Access Compliance Report

Public Rights-of-Way (Curb Ramps)

Intersection ID: 10041132	Main Street: WATERSREACH_LN	Cross Street: N/A	Location: W
ADA ID: BAA5B80B1805	Ramp Type: Perp	Initial Pass/Fail: Fail	Overall Compliance: No
Severity Score: 8.75			
Codes/Mitigation Info/Possible Solution		Field Measurements/Component Compliance

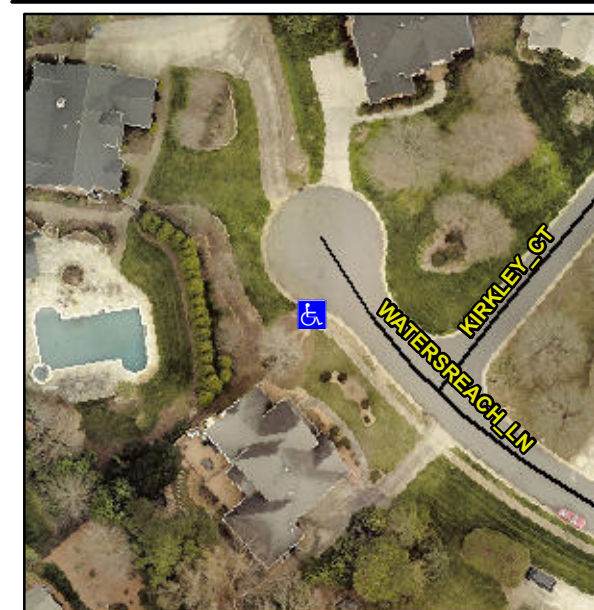
Not Found, R304.5.1

Compliance	Description	Data	Compliance	Description	Data
N/A	Ramp Length (in)	97.0	Yes	Ramp Slope (%)	5.8
No	Ramp Width (in)	47.0	Yes	Ramp XSlope (%)	2.0
N/A	Flare Type LT	N/A	N/A	Flare Type RT	N/A
N/A	Flare Slope LT (%)	N/A	N/A	Flare Slope RT (%)	N/A
N/A	Flare Traversable LT?	N/A	N/A	Flare Traversable RT?	N/A
N/A	Landing Length (in)	N/A	N/A	DWS Provided?	N/A
N/A	Landing Width (in)	N/A	N/A	DWS Contrast?	N/A
N/A	Landing Slope (%)	N/A	N/A	DWS Length (in)	N/A
N/A	Landing X Slope (%)	N/A	N/A	DWS Full Width?	N/A
N/A	Landing Curb? (Y/N)	N/A	N/A	DWS Offset (in)	N/A
N/A	Shared Landing?	N/A			
N/A	Gutter Ponding?	N/A	N/A	Gutter Slope (%)	N/A
N/A	Gutter Lip Ht (in)	N/A	N/A	Gutter X Slope (%)	N/A
N/A	Painted X Walk1?	No	N/A	Painted X Walk2?	N/A
	X Walk 1 Direction	To E		X Walk 2 Direction	N/A
N/A	X Walk 1 Width (in)	N/A	N/A	X Walk 2 Width (in)	N/A
	X Walk 1 Slope (%)	0.6		X Walk 2 Slope (%)	N/A
	X Walk 1 X Slope (%)	3.2		X Walk 2 X Slope (%)	N/A

Remove & Replace Entire Ramp.
